TECHNICAL BULLETIN

RECONFIGURATION OF CLICK-FIT FLUE OUTLET

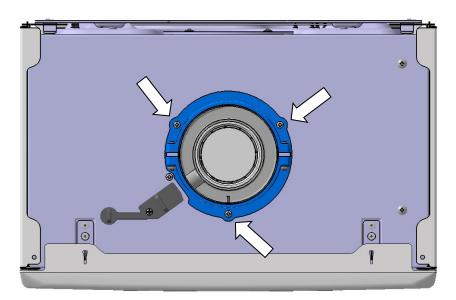
The 'Click-fit' flue outlet on the appliance can be easily reconfigured to enable a standard HE flue terminal* to be connected to the appliance, or if/when the rear flue terminal** is to be utilised.

- Locate and remove the 3 retaining screws that secure the white 'Click-fit' flange to the appliance (see below); retain the screws as they'll be required later.
- Remove the large black sealing gasket located below the 'Click-fit' flange and discard.
- **Do not remove** the black 60mm 'O' ring seal from the inner 60mm pipe
- Refit the 3 retaining screws.

The flue outlet is now ready to be used with the standard HE flue terminal* or can be closed off if the rear flue terminal** is being utilised.
